FCPS NEW MIDDLE SCHOOL – POLO CLUB KDE BG # 21-176 FCPS BID # 20-21 JRA Project No. 202078 Fayette County Public Schools Lexington, Kentucky

ADDENDUM ITEMS:

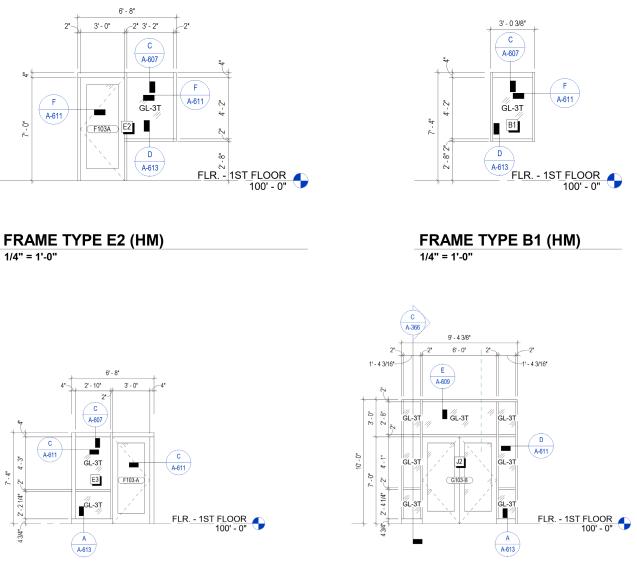
Refer to Sheet A-619 – Interior Frame Types. Revise Frame Type E2 (HM), B1 (HM), E3 (HM), J2 (HM) to clean up graphics.

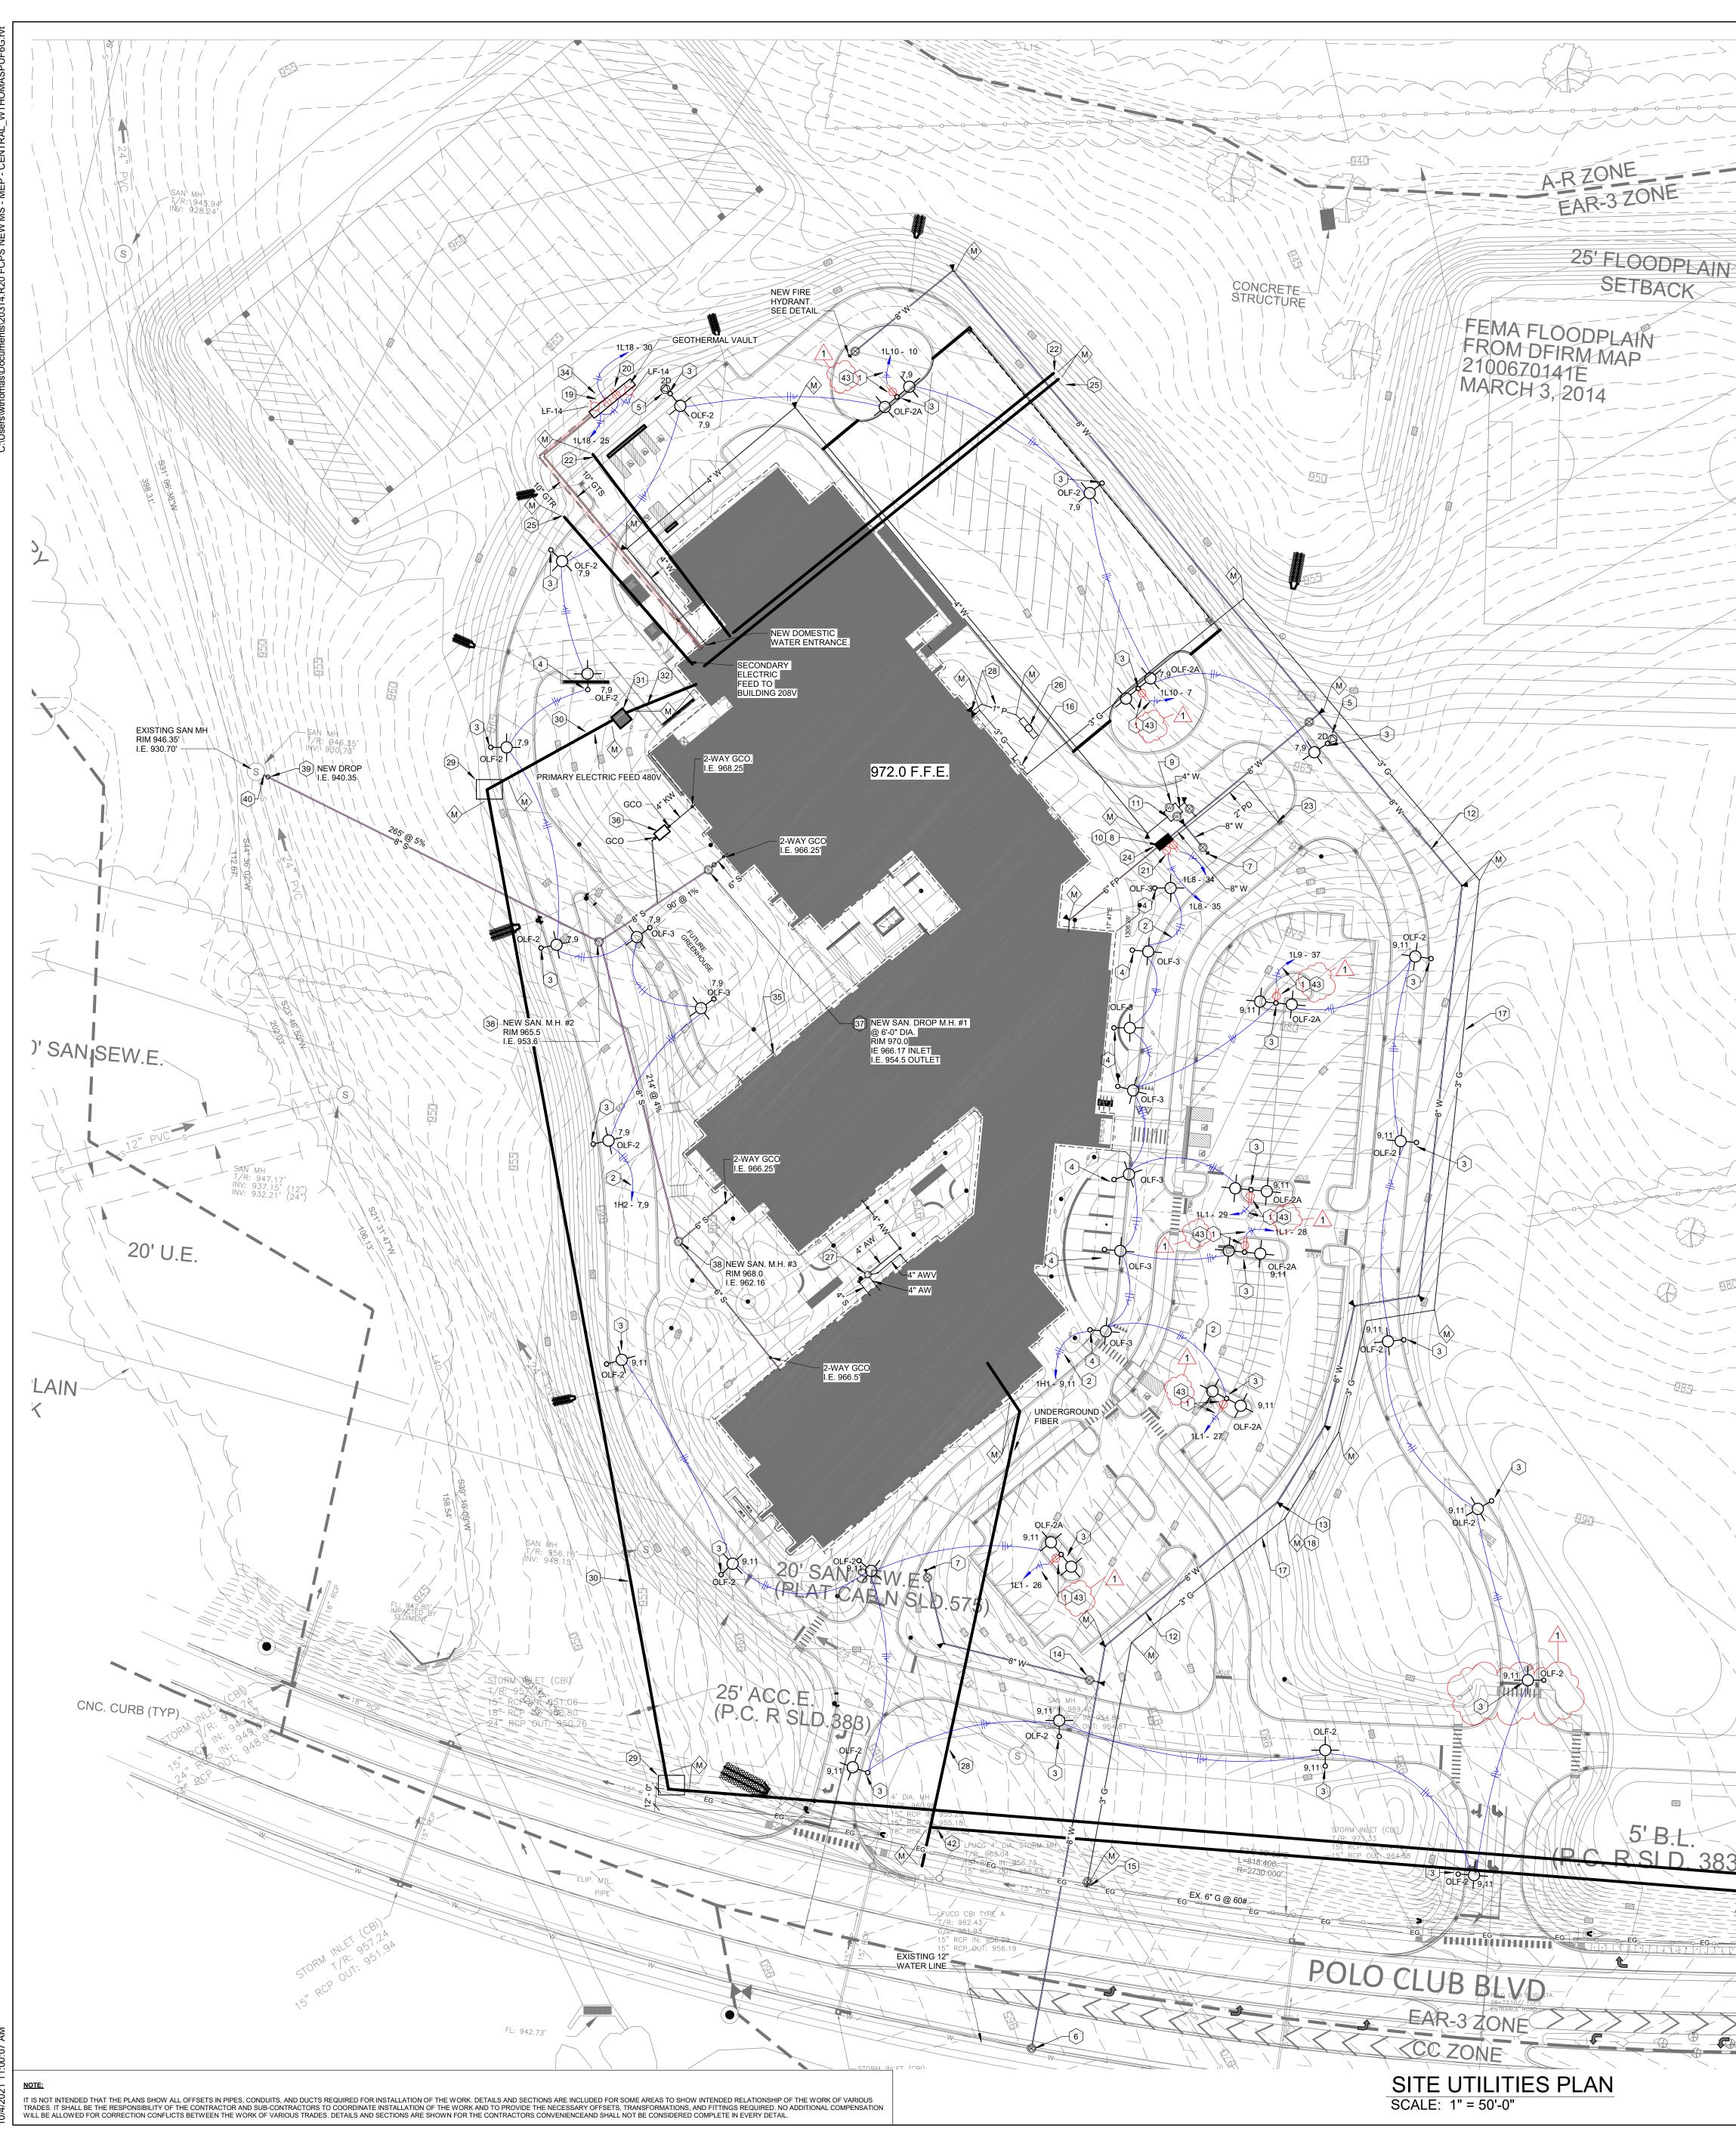
Refer to sheet U-100 – Add control of parking lot receptacle circuits by lighting control relay and switch.

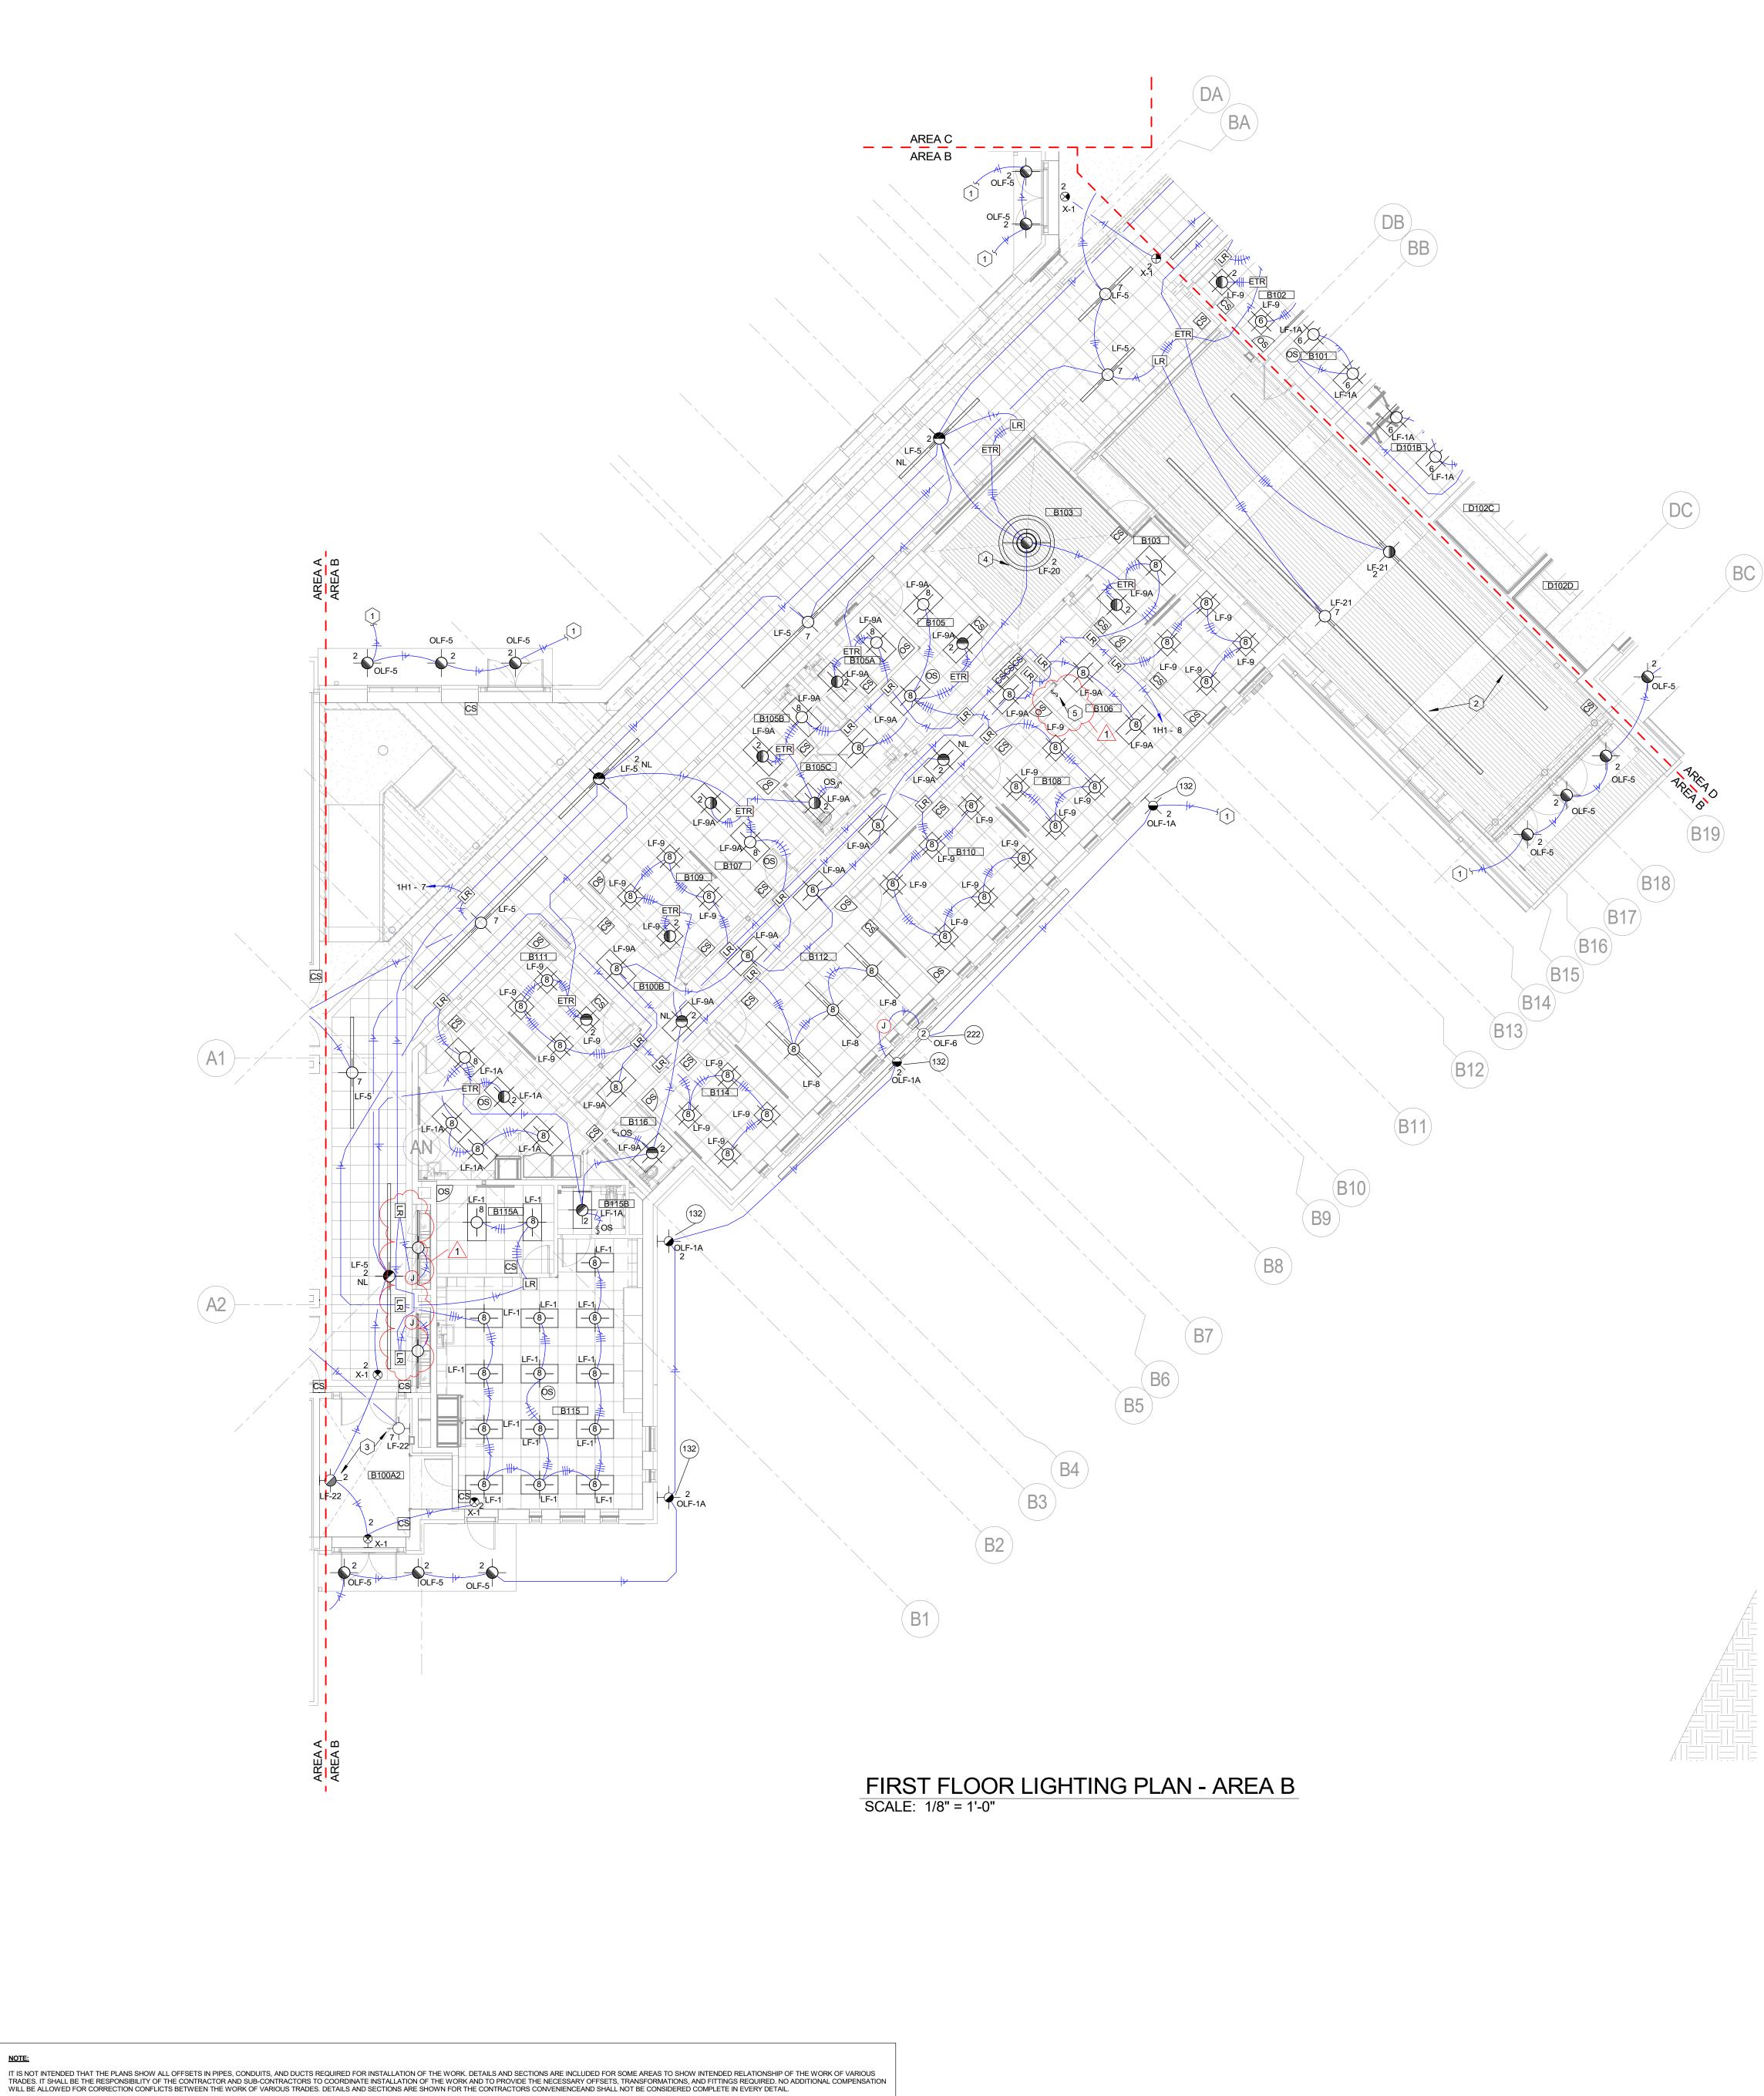
Refer to sheet E-111B – Add control of parking lot receptacles and add lighting to trophy cases.
